Contract #: 04-0120F4Cty: SF/ALA Rte: 80 PM: 13.2/13.9File #: 69.25B

QUALITY ASSURANCE -- NON-CONFORMANCE REPORT

Reference Description: Missed UT indications by QC on OBG 2AW Floor Beam Flange Weld**Description of Non-Conformance:**

Job Name: SAS Superstructure

WELD NUMBER: SSD11-PP15-002

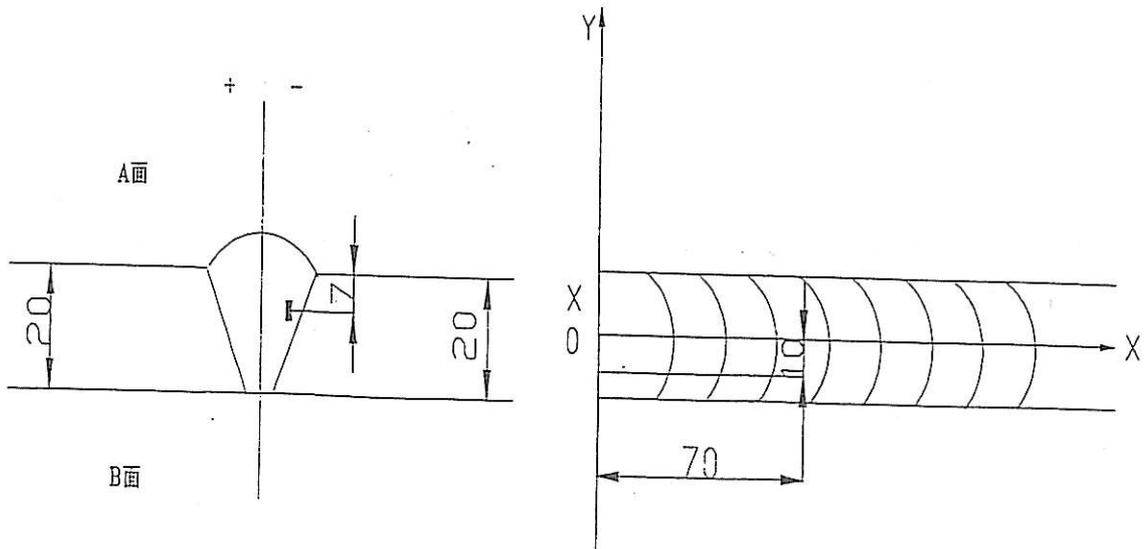
Rejected indication found by ultrasonic inspection is less than the maximum allowance aggregate length.

(UT探伤发现的缺陷总长度小于最大允许长度。) SSD11-PP15-002

1. 焊道未及时处理干净。

1. Did not clear the weld pass completely in time.

1. Gouge or grind from nearer side from metal edge ($D \leq 0.65T$, "D" is depth of defects, "T" is thickness of metal) to remove all defects;

2. Follow repair WPS for joint preparation, preheat, and weld deposit;

3. Verify with VT no defects remain in the weld joint prior to welding;

4. Grind the repaired area flush with base metal or the adjacent weld;

5. Check the welds according to the working drawings.
